# Gilston Area Strategic Landscape Masterplan

Community Working Group - Session 02 You Said We Did

GSLM605-GA-PR-0028\_CWG2 You Said We Did

March 2025

#### 5.4.6 Community Food Production

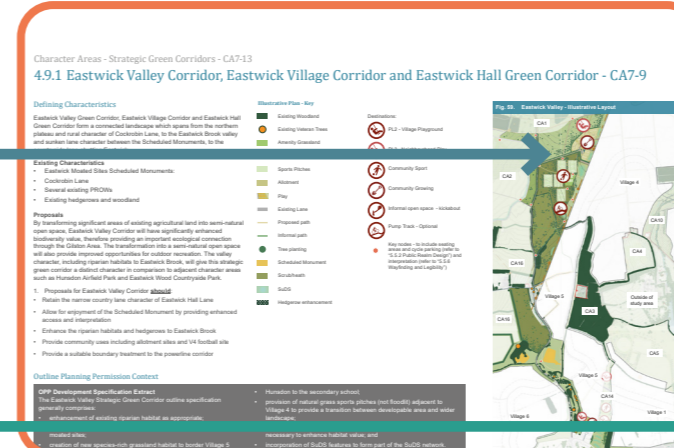
- How many allotments will there be?
- How will the allotments be managed?
- Can the allotments be in the buffer zones?

6.35ha of allotments will be provided across the Gilston Area in line with the OPP commitments set out in the Development Specification. The SLMP regulatory plans set out appropriate locations for the allotments and community orchards. Design requirements for community growing are provided within Part B of the SLMP

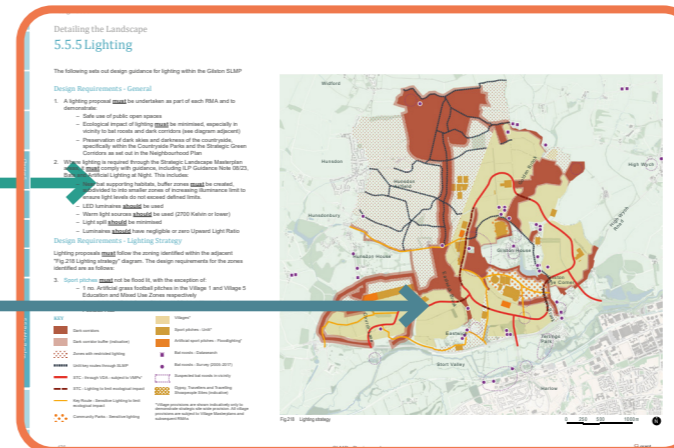
RESPECTING NATURALLY DARK AREAS: There should be a gradual change in lighting intensity from the villages to more rural areas

The SLMP establishes dark corridor buffers to ensure a transition in lighting intensity. These are shown indicatively on the plan in Chapter 5.5.5 Lighting
